TCC Submission on Part 8 Consultation Whitestown Stream Enhancement Project

2nd Sept 2021

Tara De Buitlear, Gerard Stockil, Tallaght Community Council

Approximate location of two CCTV cameras mentioned in Planning report

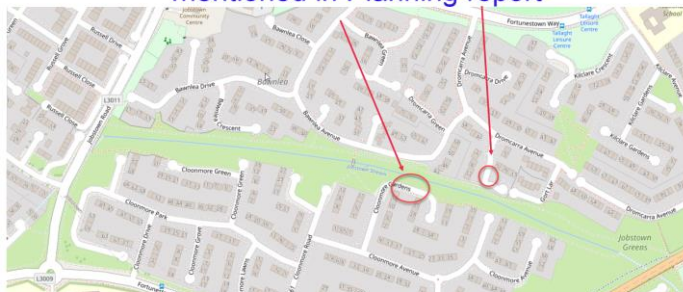
The map below shows possible locations of the CCTV posts, it is clear that there is no way that this can provide adequate coverage of all parts of the local park and as such will reduce the safety metrics and provide not deterrent potential littering and anti-social behaviour .

Locations of current CCTC are inadequate to view all the park area and give a safe environment.
New infrastructure along all of stream required.
The red circles are approximate location of current CCTV, clearly they lack visibility along all the stream

Incidental Information Area and Signage

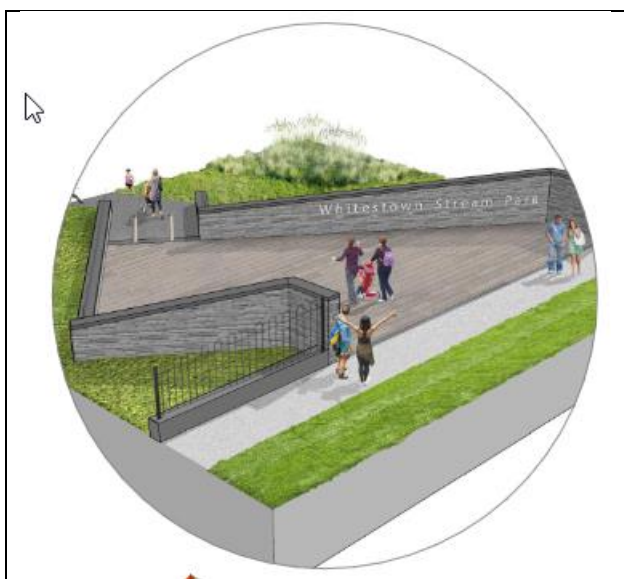
We welcome the informal play area and as that consideration be given to placing signage describing the history of the general area be inserted beside of if these area.
